2 March 2020

Project: Diesel Mechanic Shop
Copiah-Lincoln Community College
Natchez Campus
GS 202-078

Addenda No. 2

ADD#2-M-2

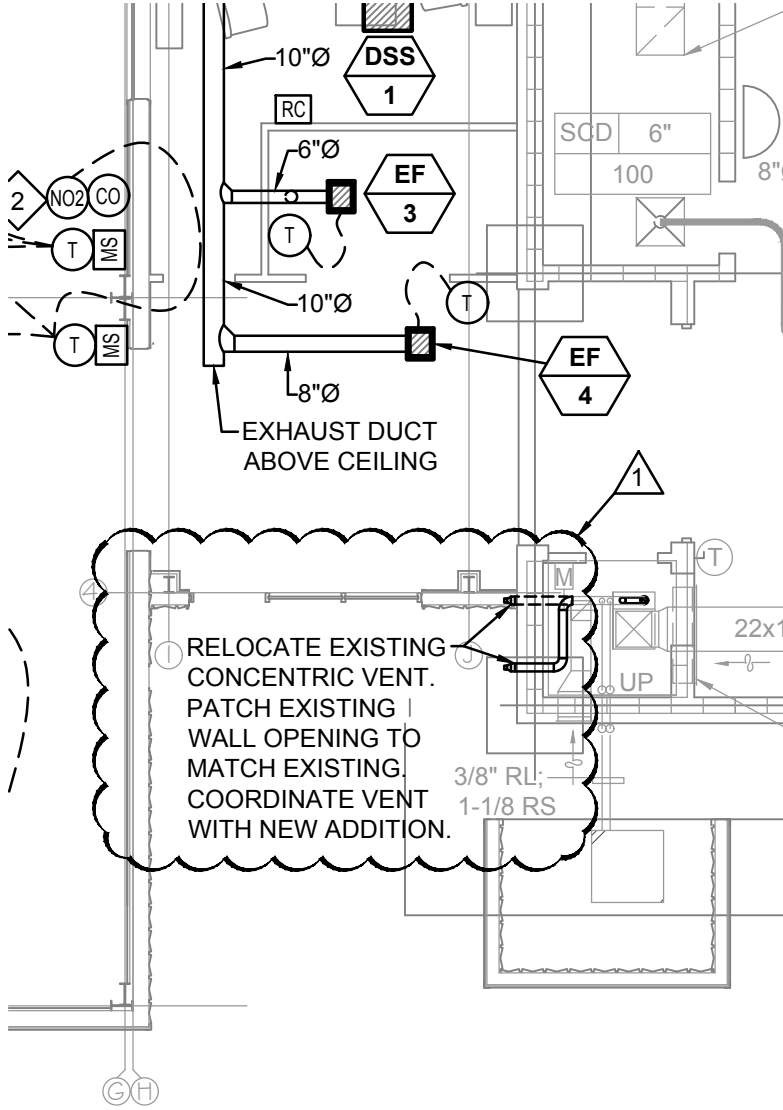
See the attached revision to sheet M-2 that addresses relocation of a sidewall hvac vent.
